MISSOURI SOUTHERN

RFP No: 26-004

ADDENDUM #1

Videoboard Replacement

SECTION ISI.I
NTS

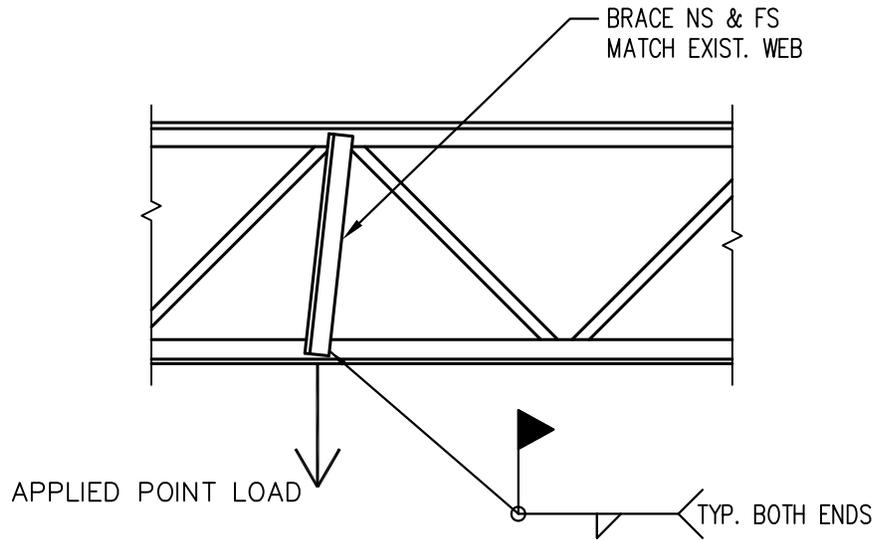
2. What is the roof weight capacity of the building in the truss section the center hung is to be installed?
 - a. Current scoreboard is 3800lbs. Anything exceeding 3800lbs, contractor will be required to work with an engineer before installation to ensure weight capacity is not exceeded. Current videoboard is not setup with winching system. New videoboard needs to be installed with a winching system and as such, if this exceeds 3800lbs, contractor will need to work with an engineer before installation.

3. What are the existing attachment points to the ceiling?
 - a. Attachment S1 below identifies the existing attachment points for the current videoboard.

NOTE:
JOISTS DO NOT REQUIRE CHORD
OR WEB REINFORCEMENT FOR NEW
3800 lb SCOREBOARD

NOTE:
SCOREBOARD PROVIDER SHALL
COORDINATE ATTACHMENT TO
ROOF FRMG. w/ ENGINEER &
OWNER
